Item Number: 3

1 Stansell Street, Gladesville

Section 4.56 modification to LDA2021/0125 being a Court approved residential flat building development. The application seeks to add a two-storey walk-up unit to the front building, changes to the communal open space area and relocation of services

**City of Ryde
 Local Planning Panel Report**

Figure 2 – Proposed site plan (proposed changes clouded in red)

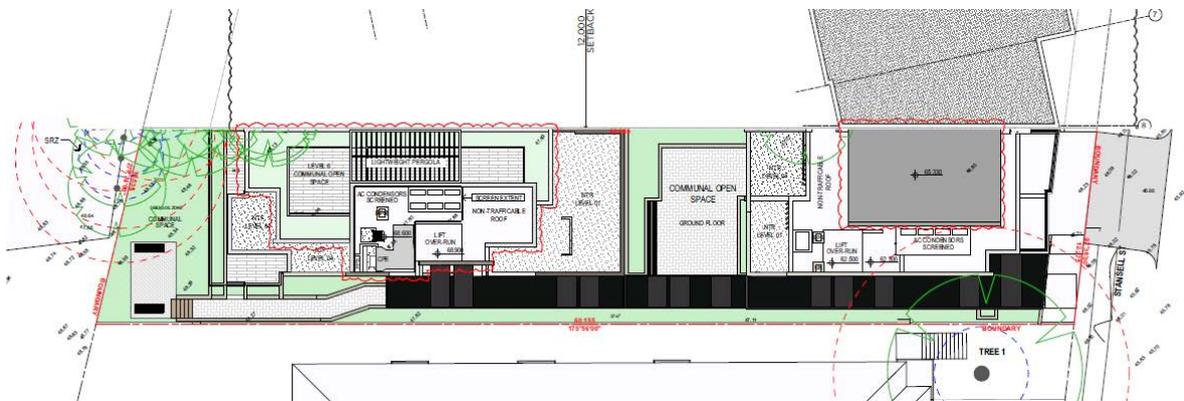
- Unit L4.02 in the front building has been redesigned to a two storey walk up unit and there is a resultant increase from one bedroom to two bedrooms for this unit.
- The level 5 communal open space in the front building has been relocated to the rear building to accommodate the two storey walk up unit. There is now a pergola structure proposed over the communal open space area and the location of rooftop services has been adjusted to suit.
- Condenser units have been relocated and screened to the eastern side of Unit 4.02 away from the building edge.
- There are minor changes proposed in the two basement levels to add a carpark exhaust fan room and relocate storage cages and bicycle spaces.

Figure 7 – Building height plane diagram from front of site (the building in green shading is the adjoining approved building at 287-295 Victoria Road)

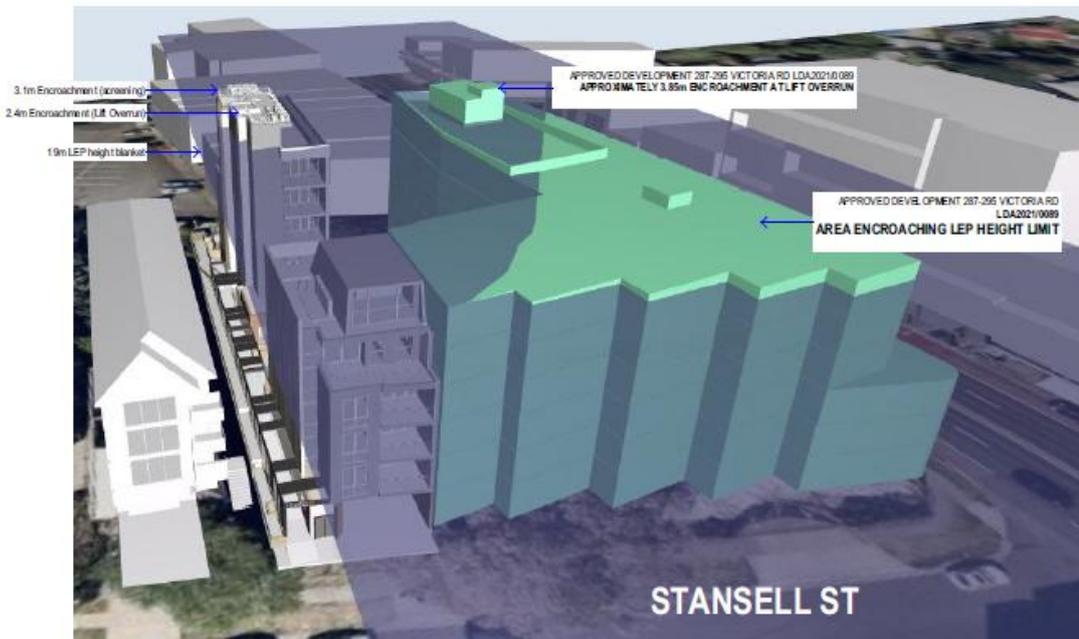
The elements encroaching above the height limit are the fire stairs, lift overrun and lift lobby which occupy an area of 35.5m². There is a rooftop pergola structure proposed also which occupies an area of 21.9m² but is an open, lightweight structure. The remainder of the subject building and the entirety of the front building comply with the building height control.

As the building height variation is limited to the rear building, it will not be visible from the public domain in the event that the adjoining development at 287-295 Victoria Road is constructed as approved (construction is yet to commence at the time of writing this report but the applicant is in the process of addressing conditions of consent to facilitate the issue of a Construction Certificate). The rear building will be shrouded from the public domain by the front building.

Figure 9 – Building height diagram (the building in green shading is the adjoining approved development at 287-295 Victoria Road)

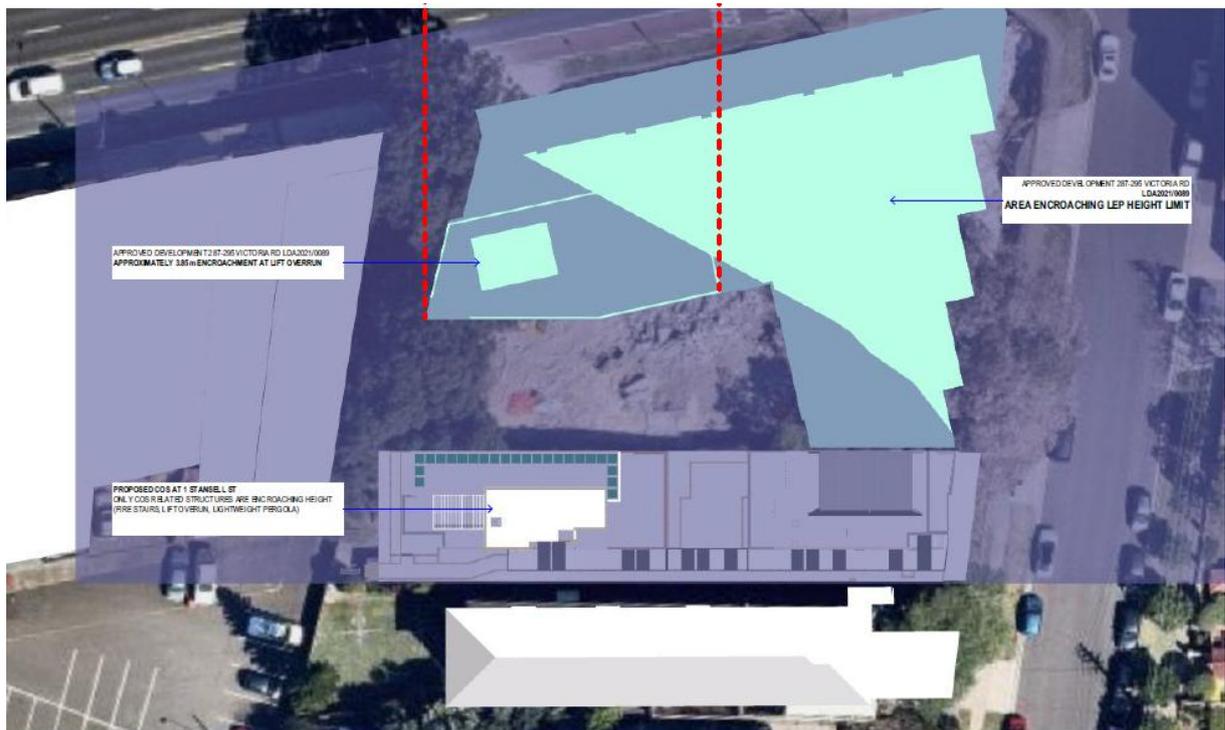
It is noted that the area encroaching above the height limit does not contain any windows, therefore there will be no additional privacy impacts to the adjoining property to the east. Further, the additional height will only result in minor additional overshadowing on the adjoining property to the east from 1pm to 3pm on June 21 (winter solstice) given the small footprint of the lift overrun, lift lobby and fire stairs.

To the west, the area of the height variation, being the rooftop pergola, will interface with the approved development at 287-295 Victoria Road. This portion of the development will adjoin a ground floor communal open space area which is supplemented by a rooftop communal area. The proposed rooftop pergola will only result in a subtle overshadowing increase on this adjoining development.

Figure 10 – Extract of rooftop plan depicting stepped setback to east

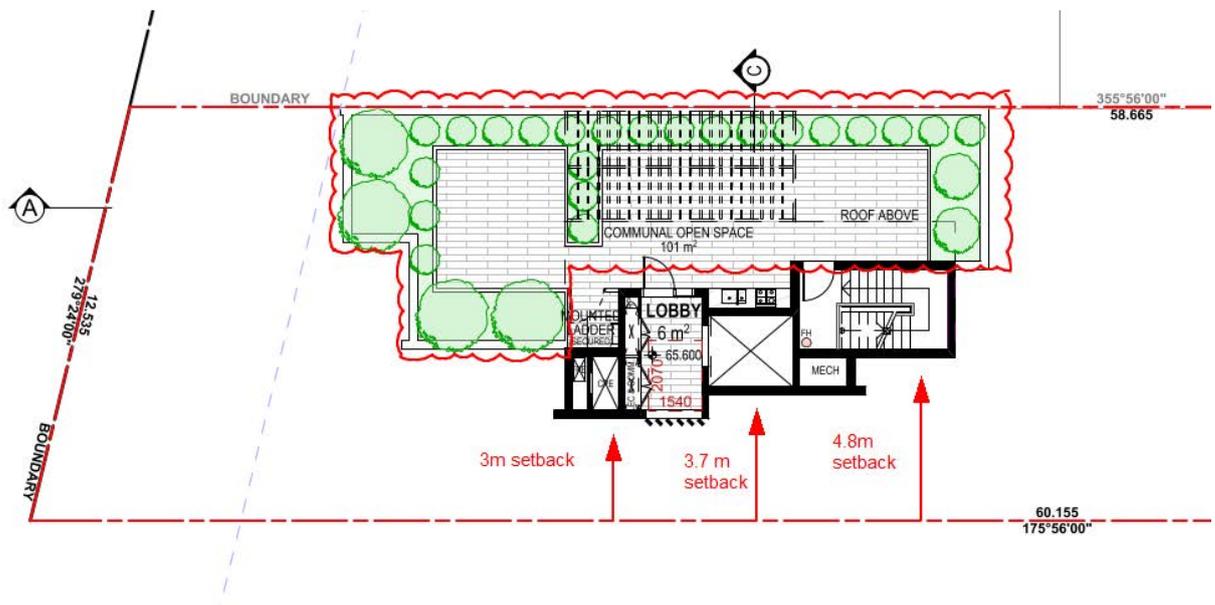
The most impact from the proposed height variation will occur to the older style three storey residential flat building located to the east. The lift lobby is set back 3 metres from the eastern boundary and the side wall of the lift lobby is 4 metres in length. The setback then steps back for the lift overrun to 3.7 metres for a length of 4.6 metres and then steps back for the fire stairs to 4.8m for a length of 2.9 metres. The area of non-compliance is therefore well articulated as viewed from the east as shown in **Figure 10**.

BASEMENT 01
SCALE 1:200

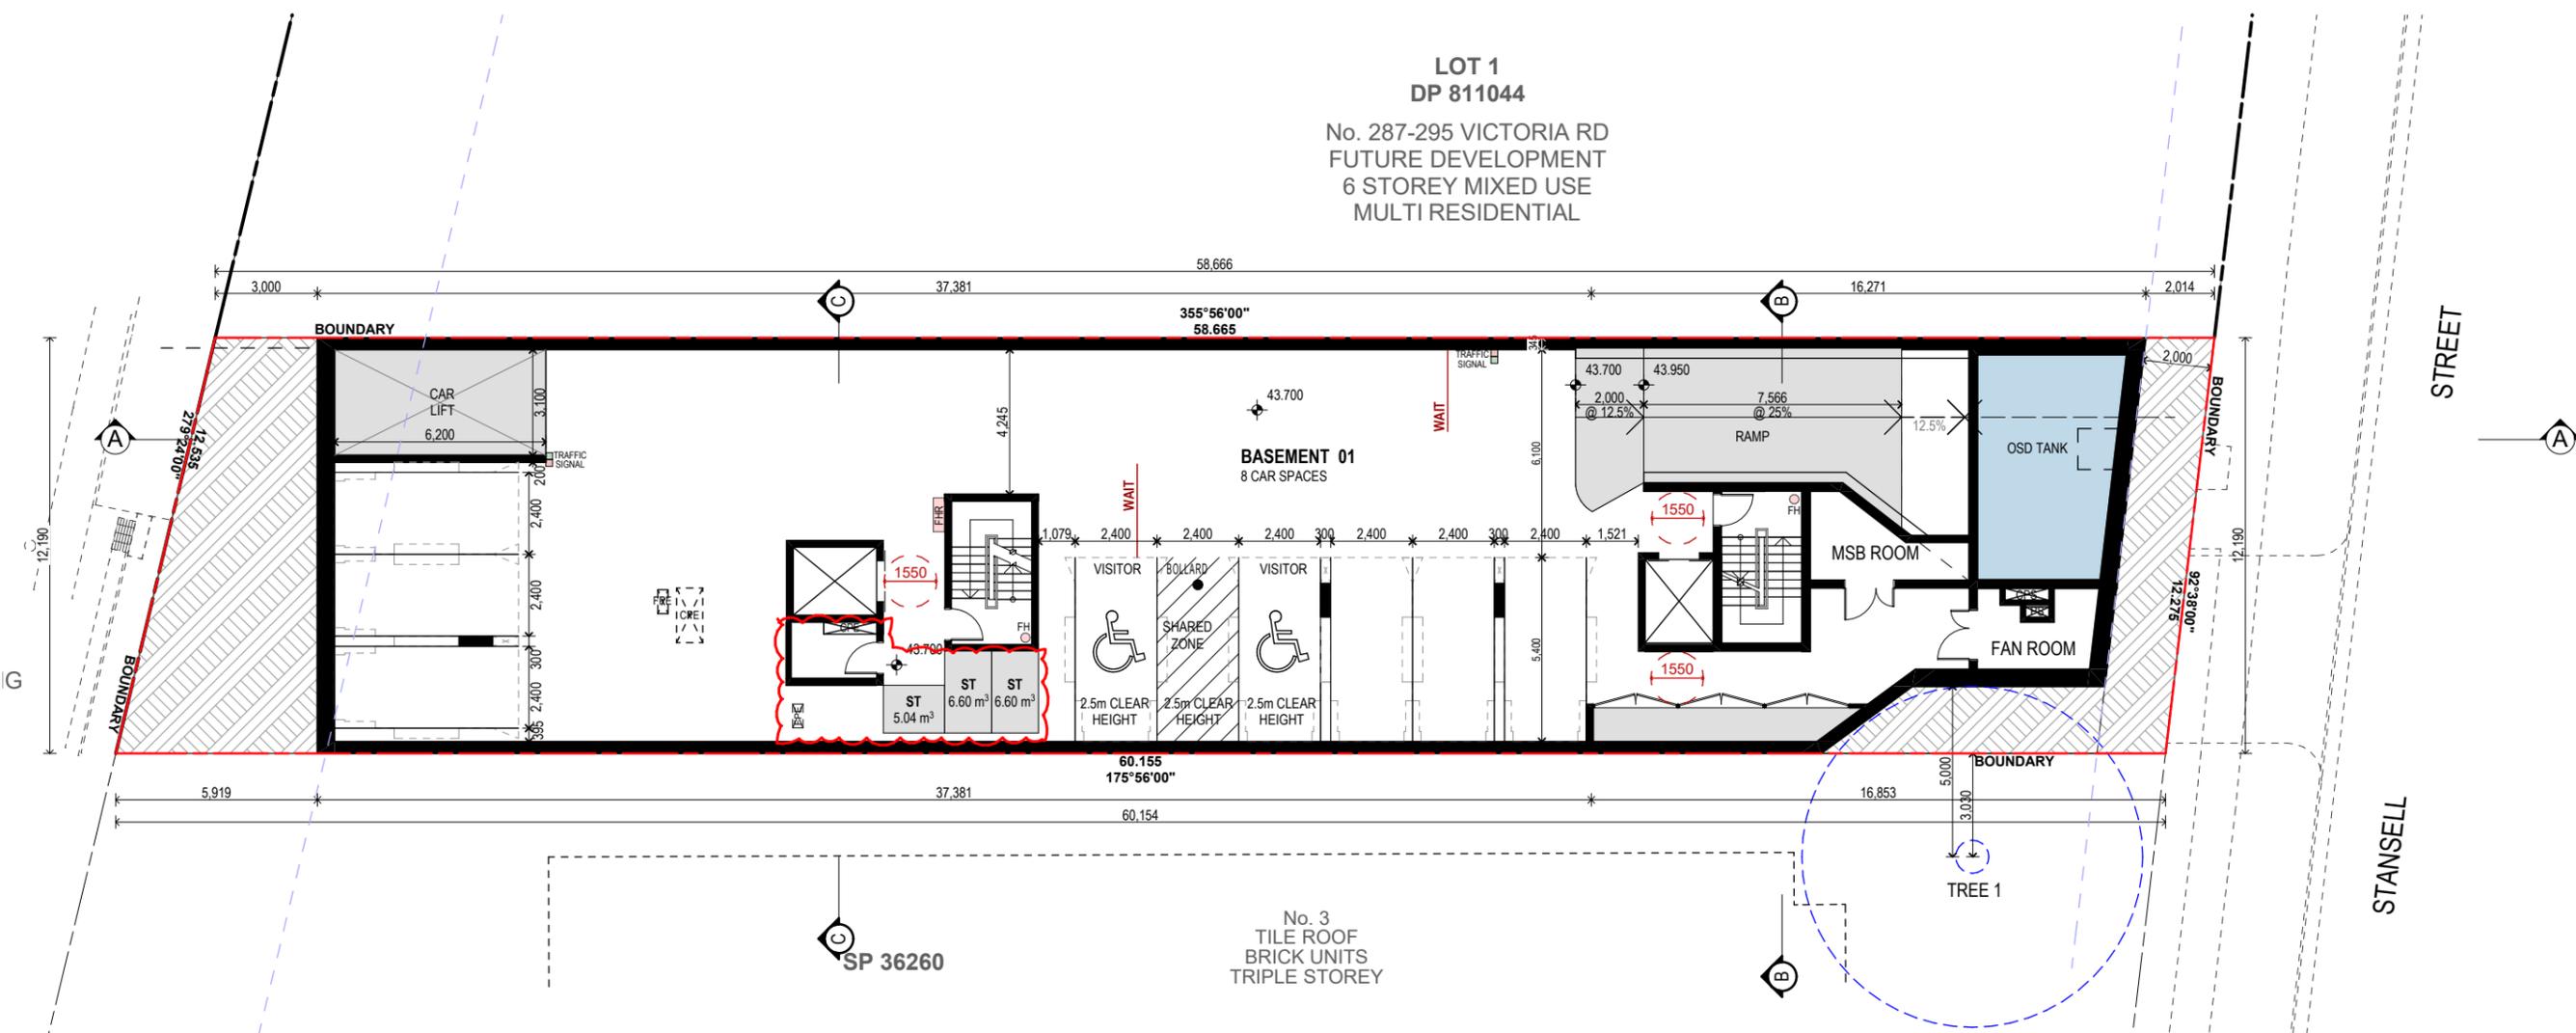
SCHEDULE OF AMENDMENTS
 - ADDITION OF CARPARK EXHAUST FAN ROOM
 - FPE RELOCATED

NORTH ELEVATION (STANSELL ST.)
SCALE 1:200

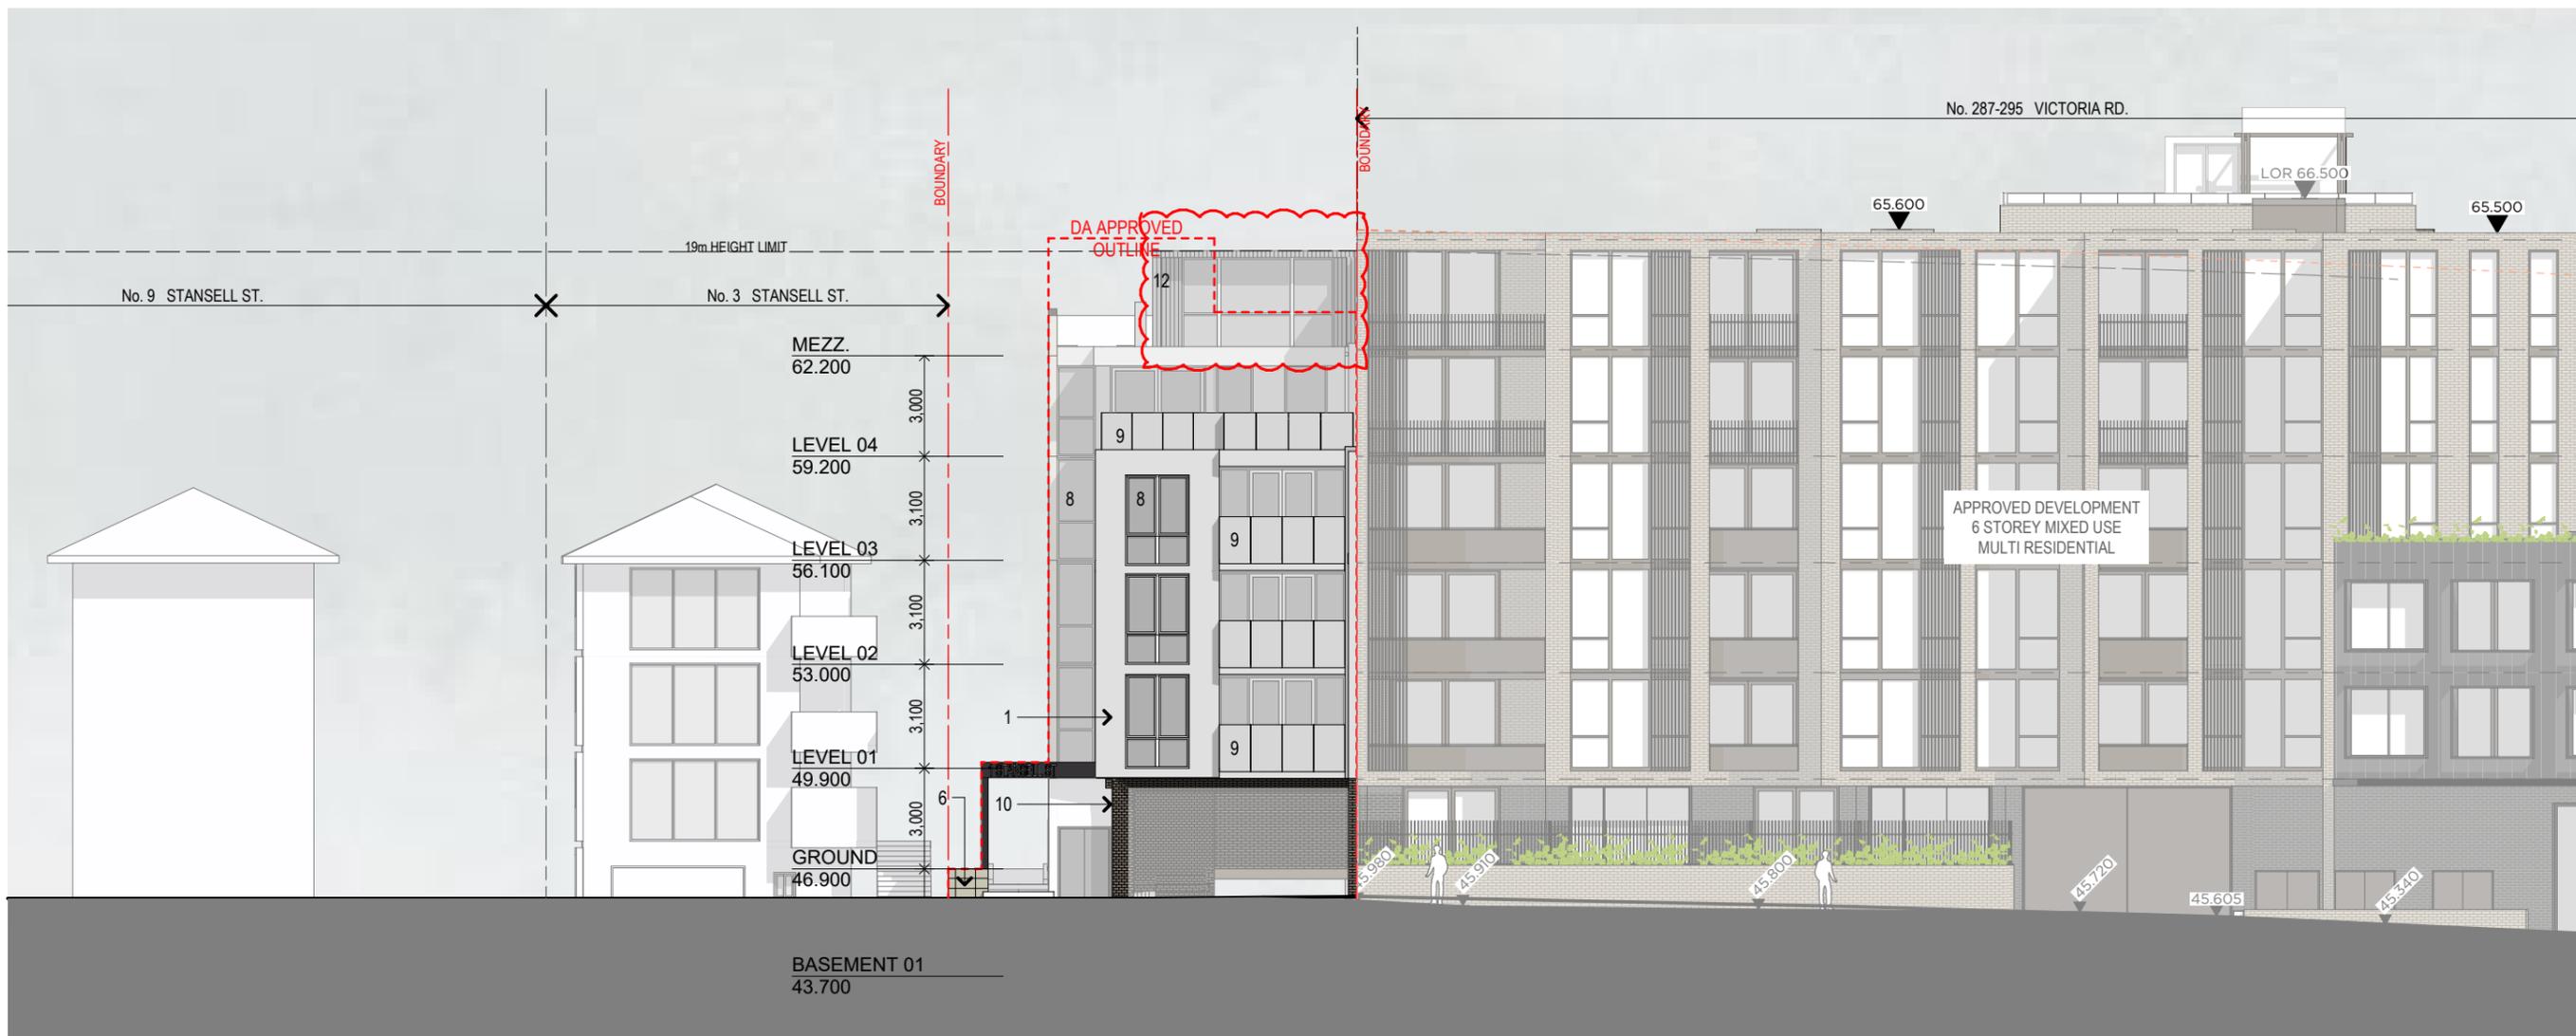
SCHEDULE OF AMENDMENTS
 - ADDITION OF COMMUNAL OPEN SPACE
 - ADJUSTMENT OF SERVICES
 - ADDITION OF LIGHTWEIGHT PERGOLA AND PLANTERS
